Airworthiness Directives; Boeing Model 767 Series Airplanes Powered by Pratt & Whitney JT9D-7R4 Series Turbofan Engines or General Electric CF6-80A Series Turbofan Engines

ACTION: Notice of proposed rulemaking (NPRM).

Boeing: Docket 98-NM-363-AD.

Figure 1

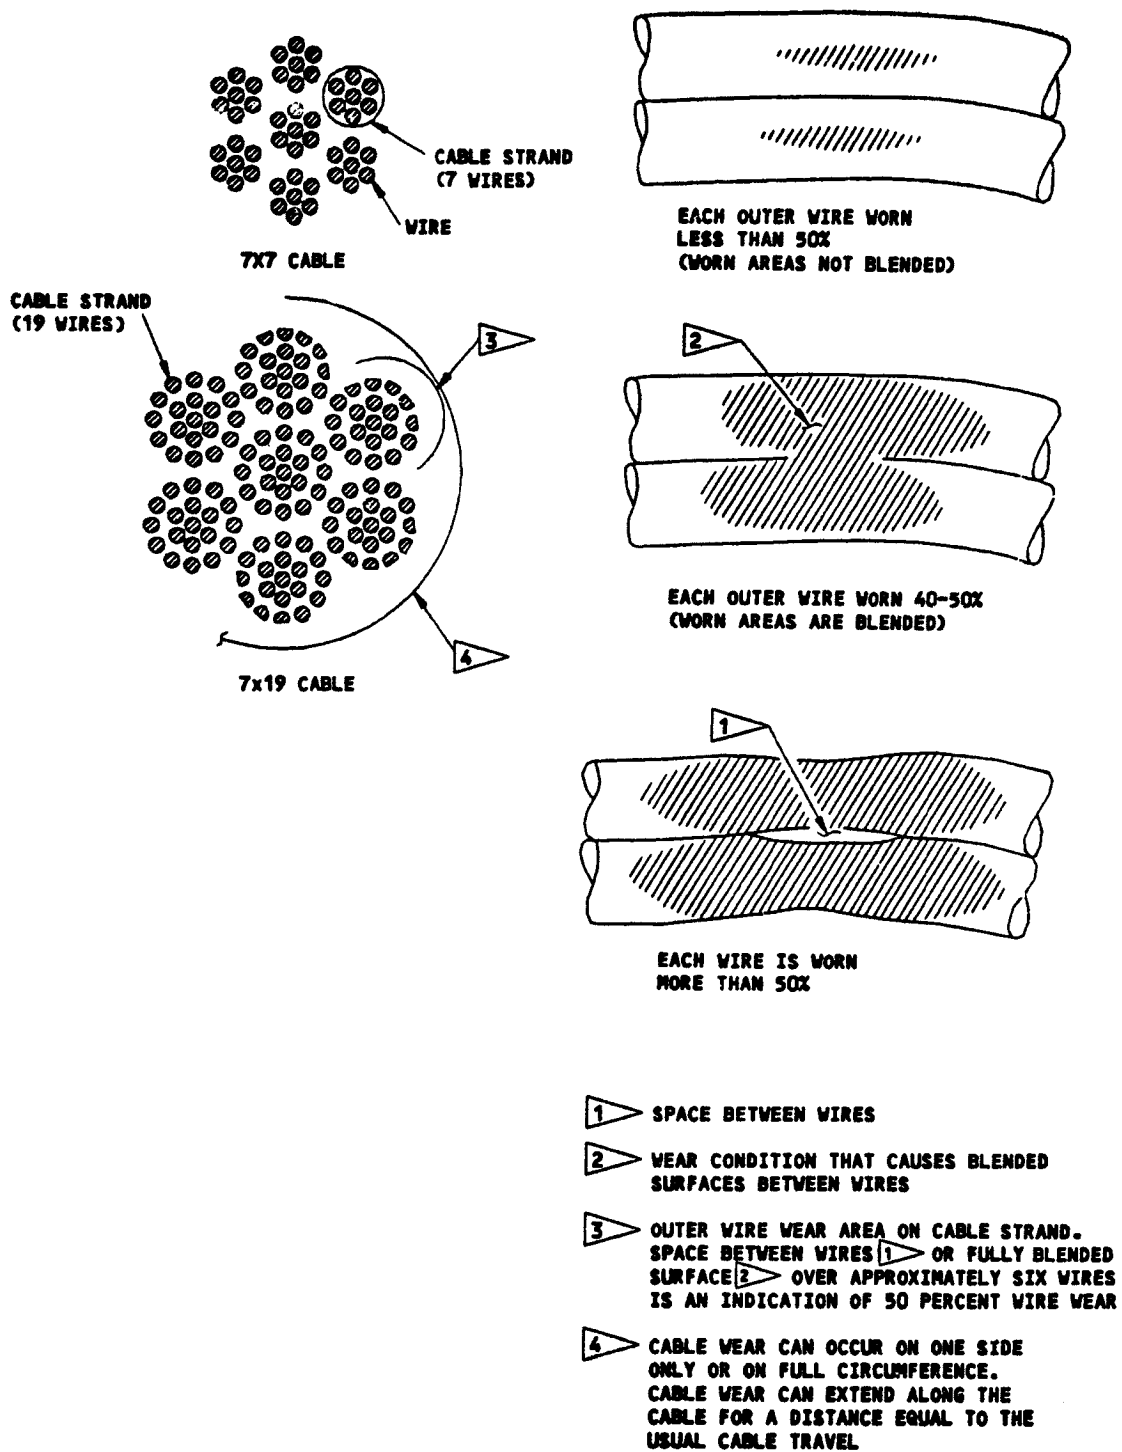
- (1) Two or more broken wires.
- (2) If one cable strand has worn wires where one wire cross section is decreased by 40 percent or more (see Figure 1).
- (3) For cables not in the pressurized area, replace a worn cable where you cannot identify the wire strands on the worn side.
- (4) A broken wire in the area that goes over a pulley, through a pressure seal, or through a fairlead.

Pulley Wear Patterns

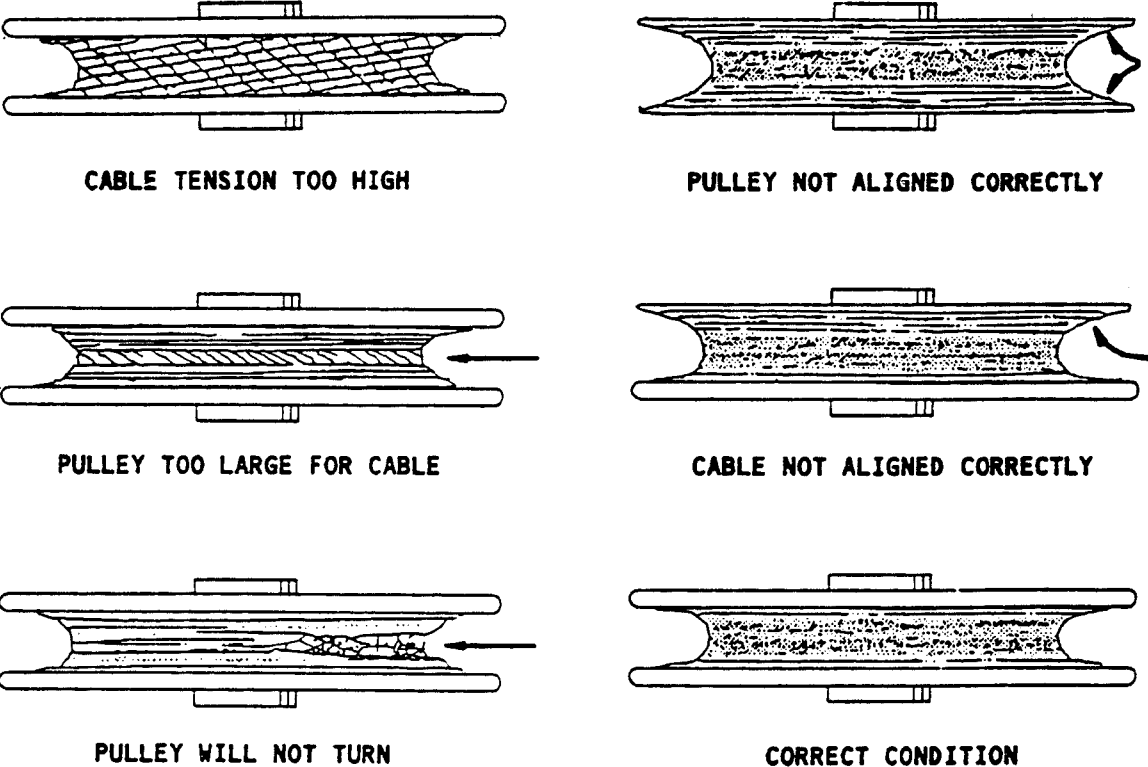
B. Visually examine the pulley wear pattern (see Figure 2).

F. Replace the pulley when you find one of these conditions:

- (1) An unusual pulley wear pattern.
- (2) Too much pulley wobble.
- (3) The pulley does not turn freely and smoothly.
